Service Bulletin

Subject: Clamshell arm seal update

Replacement Platen Arm Seal 4604236

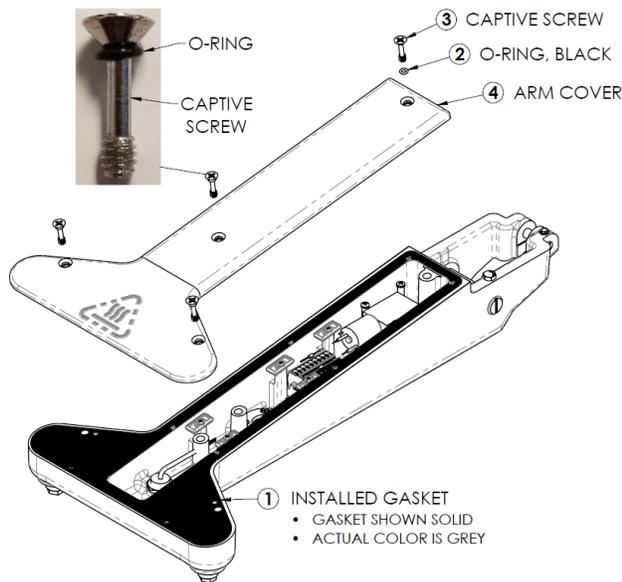
As part of our commitment to continuously improve and enhance our products we have now developed a new platen arm seal and O ring kit.

The Arm cover gasket has been designed to work with both types of arm designs. The O rings however are only designed to work on the high pressure cast arm. This is easily recognized by the fixing screws. The high pressure cast arm lid will be secured with 4 screws. And the original arm was fitted with dual steel covers and 12 screws.

Each kit will come with instructions however below is an idea of how this kit fits. Note a significant change that this seal now covers the outer previously unsealed areas

Please ensure you remove the old seal when installing this new design.
